DART AEROSPACE LTD		Work Order:	111 380
Description: Crosstube Assembly (205/212/412 High Fwd)		Part Number:	D212-664-141
Inspection Dwg: D212-664-141 Rev: D		Page 1 of 2

DRAWING NO. D212-664-141	TITLE XTUBE ASSY (205/212/412 HI FWD)	REV. D	DART AEROSPACE LTD ENGINEERING ORDER		D.E.O. NO. D212-664-141-D-1	SHEET NO. SHEET 1 OF 2	SCALE NTS
DRAWN	CHECKED	<i>RP</i>	MFG. APPR.	<i>RP</i>	APPROVED	<i>RP</i>	DE APPR.
DATE 11.04.07	DATE 11.04.11		DATE 11.04.12		DATE 11/04/12		DATE 11.04.12

**D212-664-141/-141B
ASSEMBLY DETAIL**

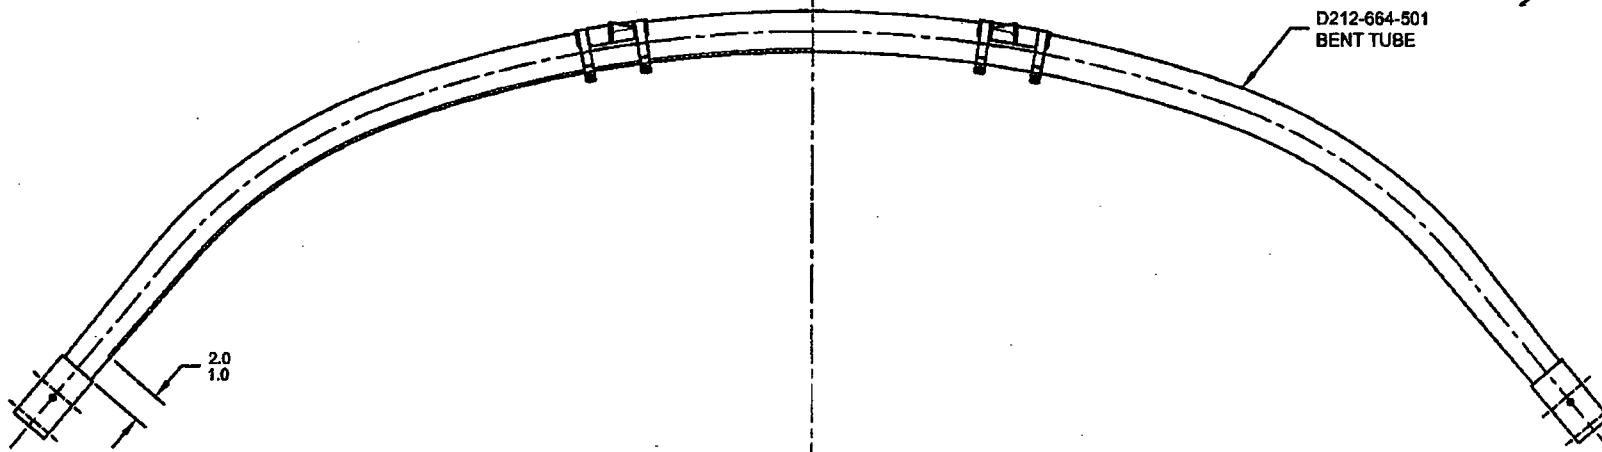
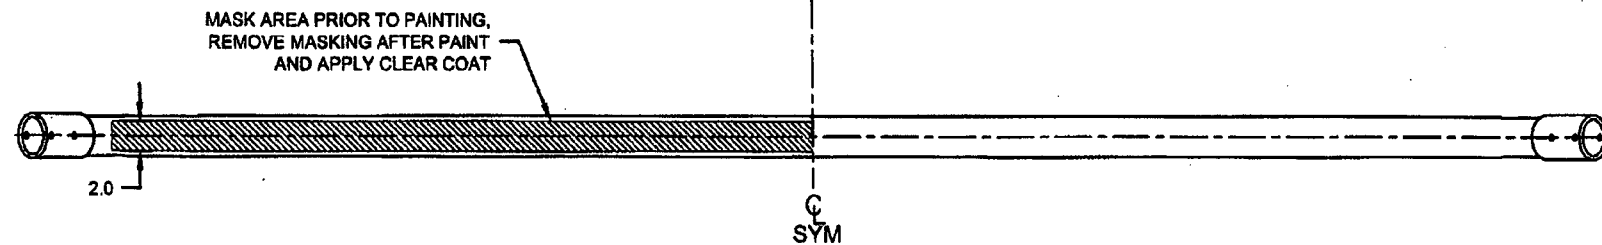
PURPOSE:

ADD AN INSPECTION WINDOW TO UNDERSIDE OF CROSSTUBE.

NOTES 2 OF SHEET 1 IS AMENDED AS FOLLOWS:

IS:

- 2) FINISH: CHEMICAL CONVERSION COAT PER DART QSI 005 4.1
PRIME INSIDE AND OUTSIDE PER DART QSI 005 4.2
MASK UNDERSIDE OF CROSSTUBE AS SHOWN (HATCHED AREA) AND
PAINT OUTSIDE PER DART QSI 005 4.2
REMOVE MASKING AND APPLY CLEAR COAT
